**NRC Concerns Relating to
Steam Generators at
Indian Point Unit 2**

**Public Meeting with ConEd
July 21, 1998^g**

**Emmett Murphy, (301) 415-2710
Division of Engineering, NRR
U.S. Nuclear Regulatory Commission**

Staff Concerns Identified in July 20, 2000 Letter

Figure 8-7
SG 4, U-Bend Tube R2C74, Crack Depth Profiles
Comparison of 800 kHz Pre and Post In Situ Test
NDE Depth vs. Axial Length

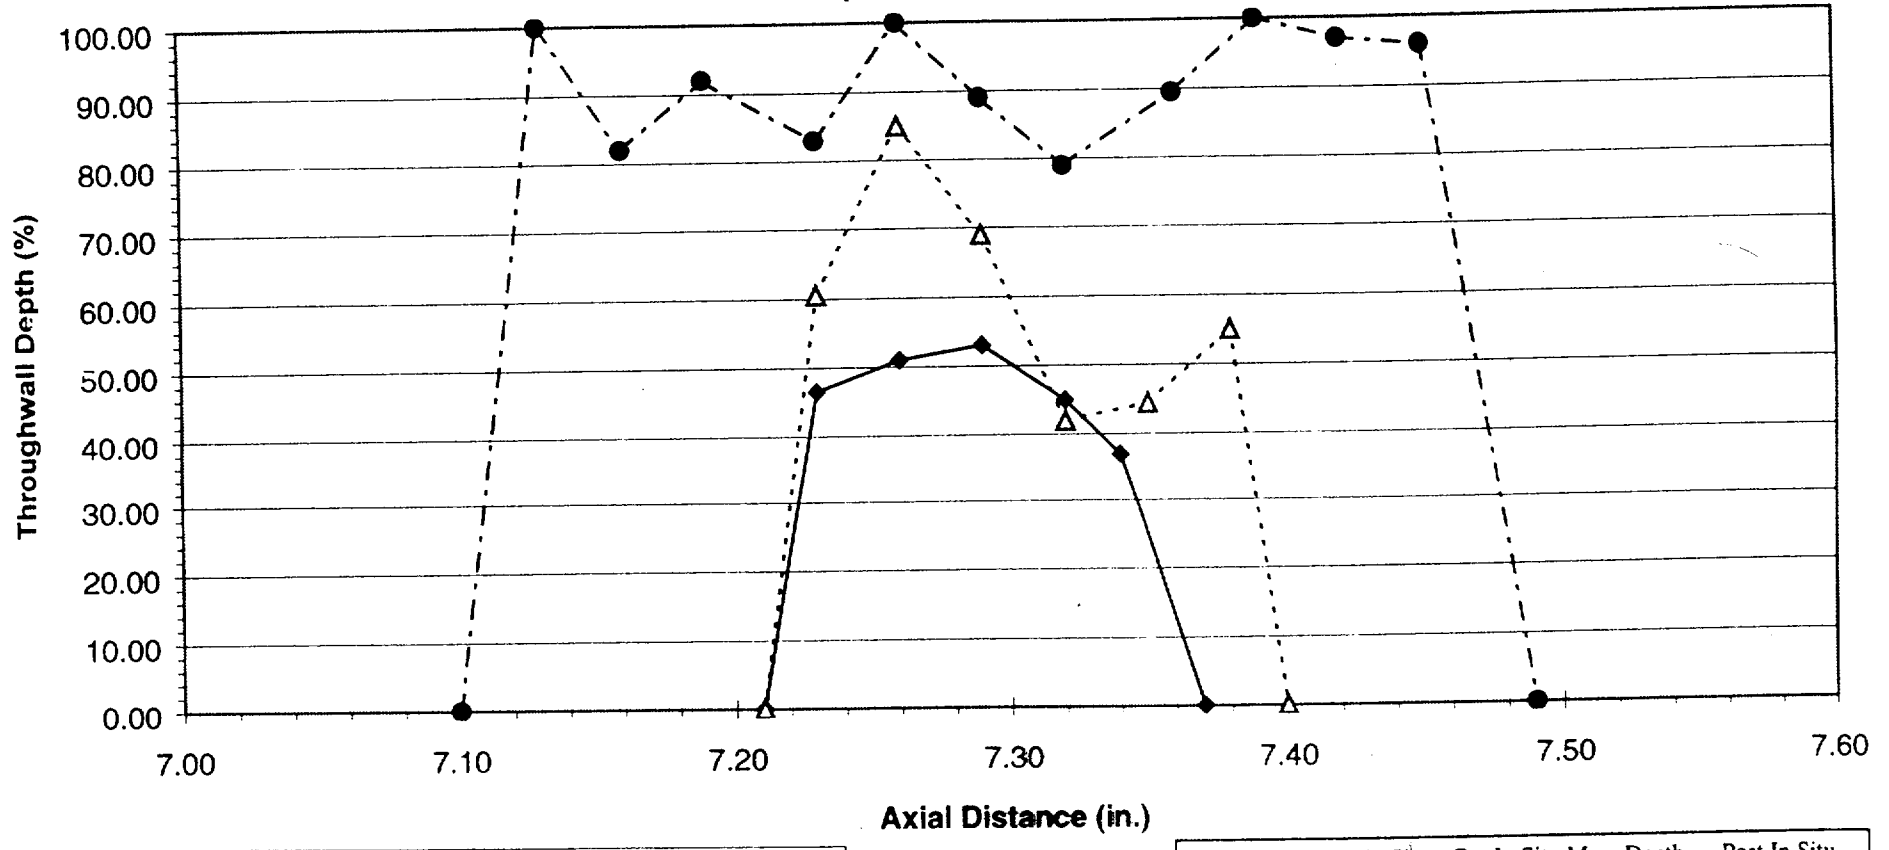
Flaw Size Measurement Error (Cont)

- The above concerns notwithstanding, the staff considers flaw sizing measurements based on the high frequency probe 800 KHz data to be more accurate than those based on the mid-range probe 400 KHz data due to significantly improved signal to noise.
 - Burst pressure estimates based on the 800 KHz flaw size measurements are 18% lower than those based on the 400 KHz measurements. Licensee needs to explain why its analysis appears insensitive to which set of measurements is used.
- The staff believes the results of the licensee's analyses are very sensitive to the assumed measurement error distribution. These distributions are used to estimate the number and size of flaws which may remain undetected in tubes which are still in service.
